TESTIMONY OF THE MAPLEWOOD CITIZENS ASSOCIATION

RE: STATE HIGHWAY ADMINISTRATION MANDATORY REFERAL PROPOSED INTERSECTION IMPROVEMENTS

West Cedar Lane and Rockville Pike (Route 355)

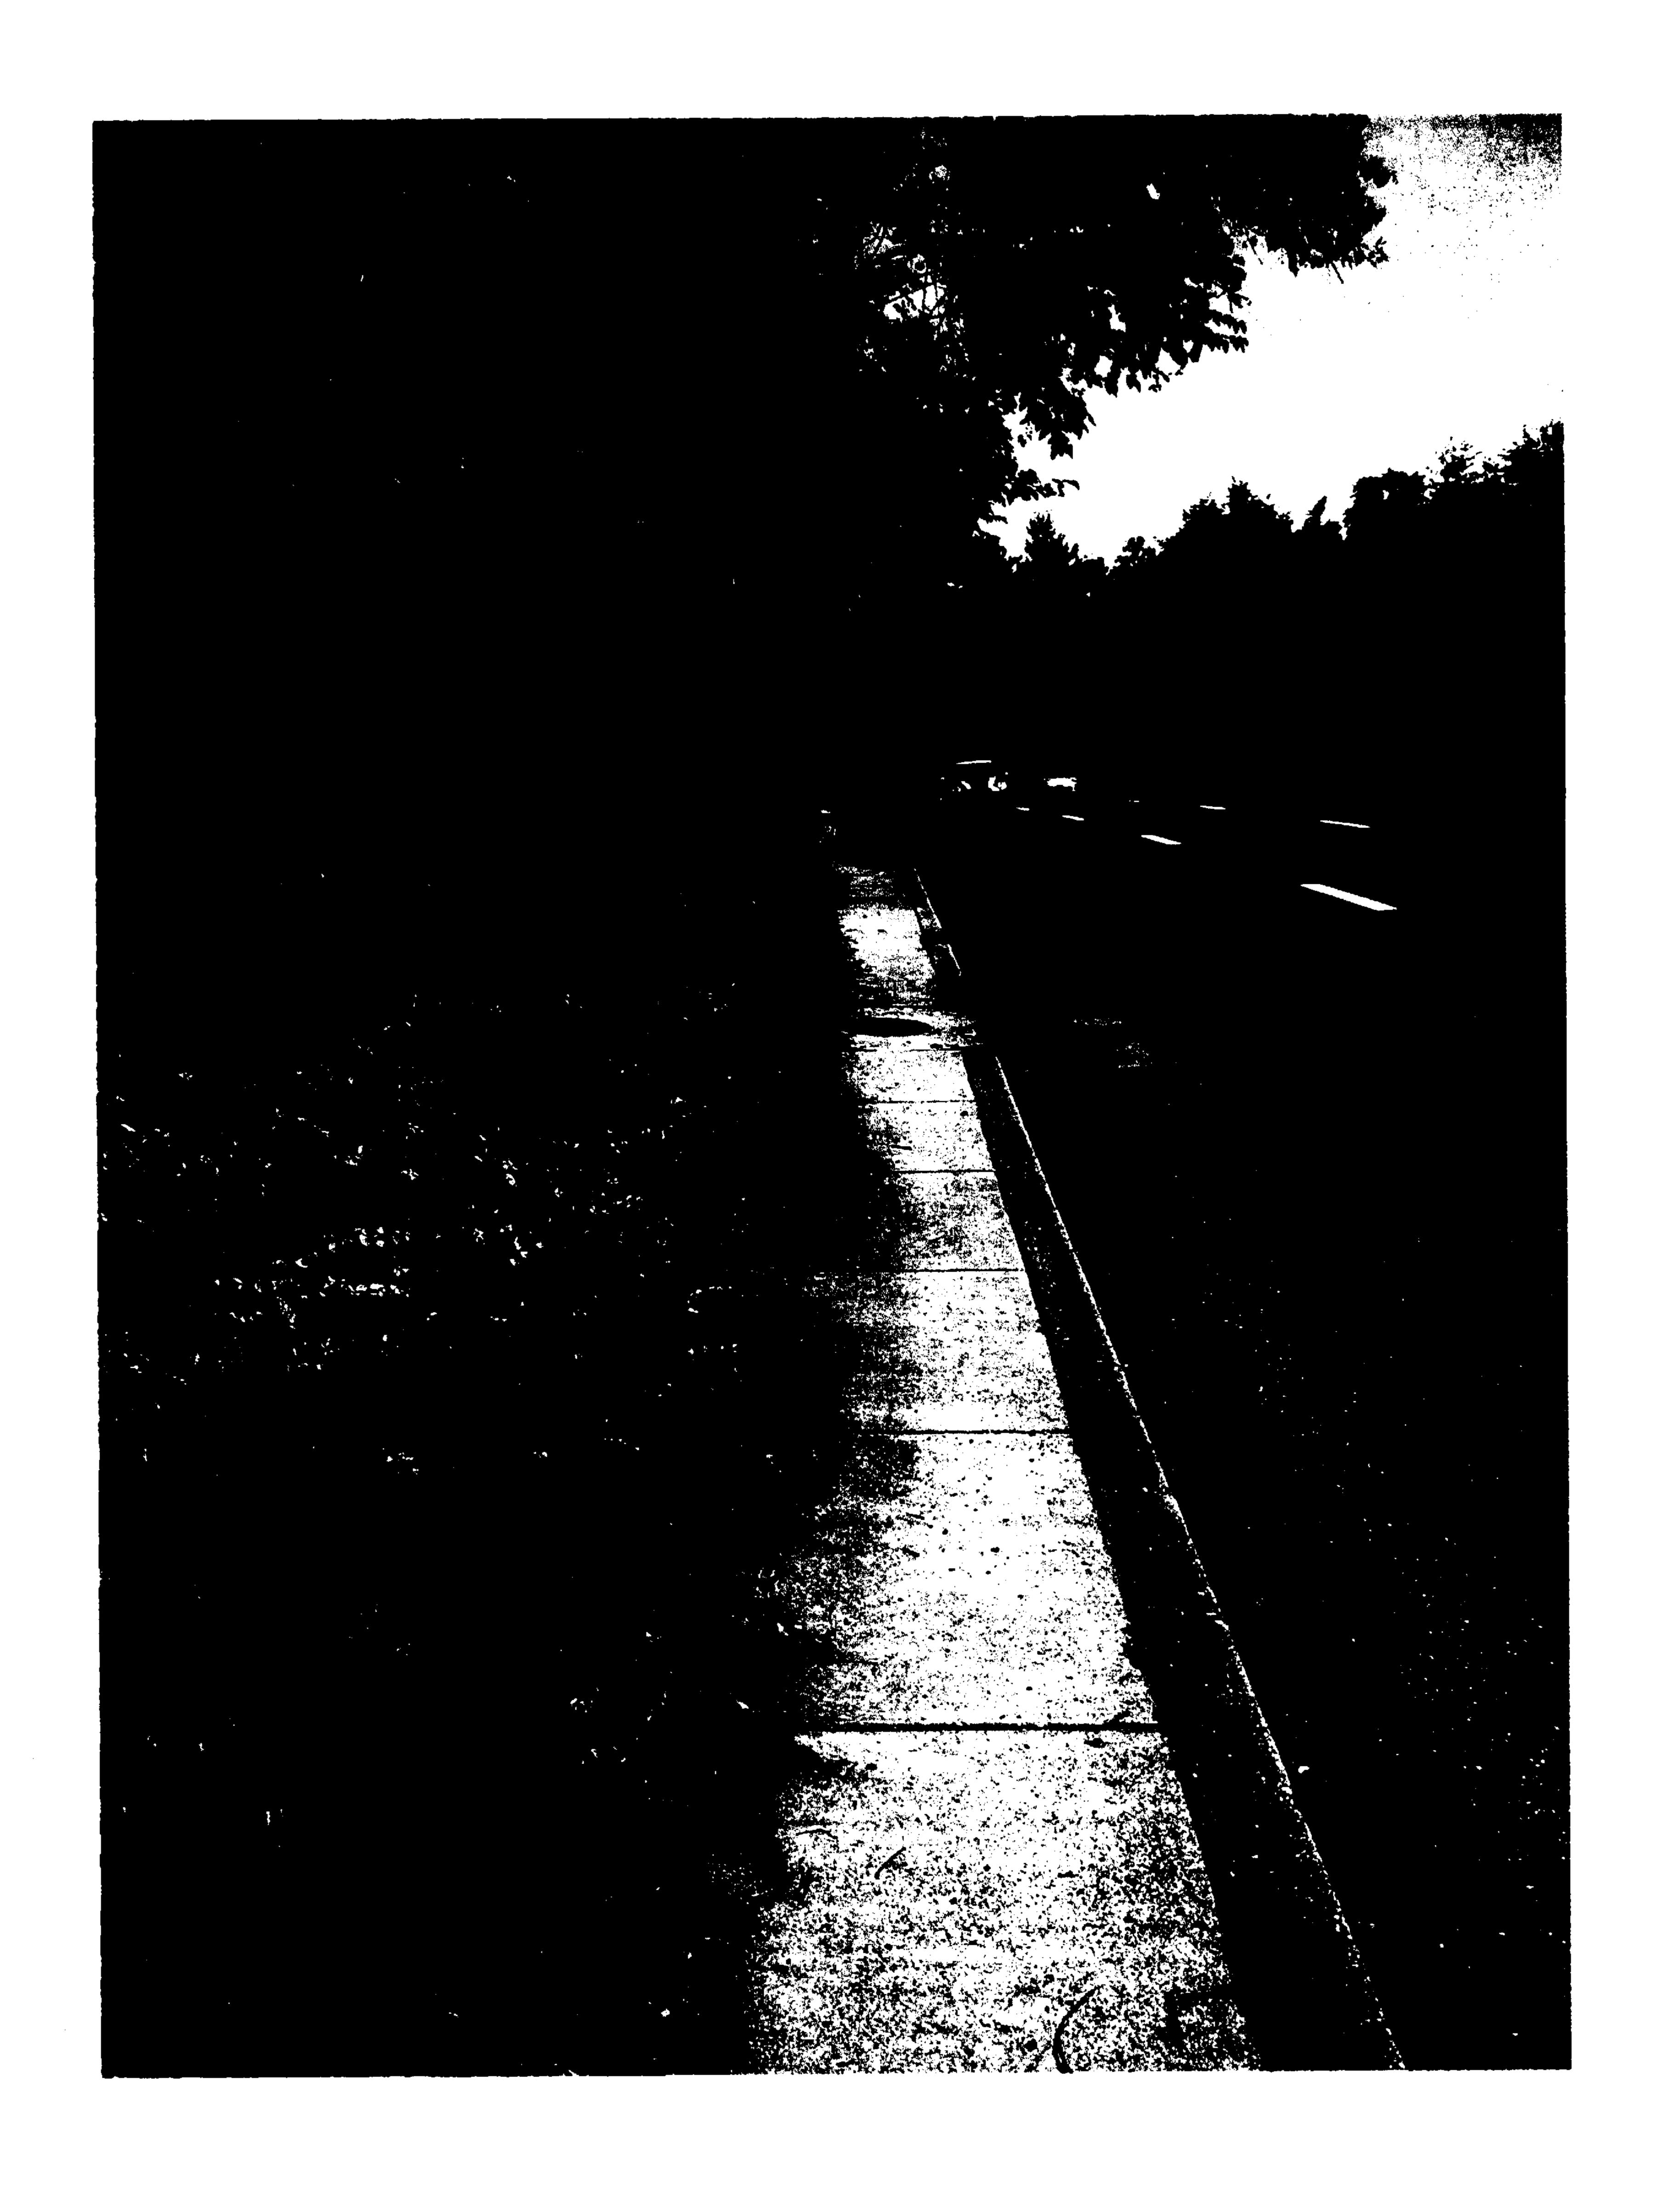
The next photograph is of the area in front of the Bethesda Crest townhouses where AASHTO guidelines were not followed and the sidewalk is along the roadway and adjacent to a retaining wall.

The last two photographs were taken in front of the Bethesda Meeting House – immediately North of Bethesda Crest. Note the narrow and meandering sidewalk and that SHA needs to do some weed trimming!

In short, MCA believes that there is no need for a retaining wall and that the existing sidewalk on the NW corner of the intersection should be maintained.
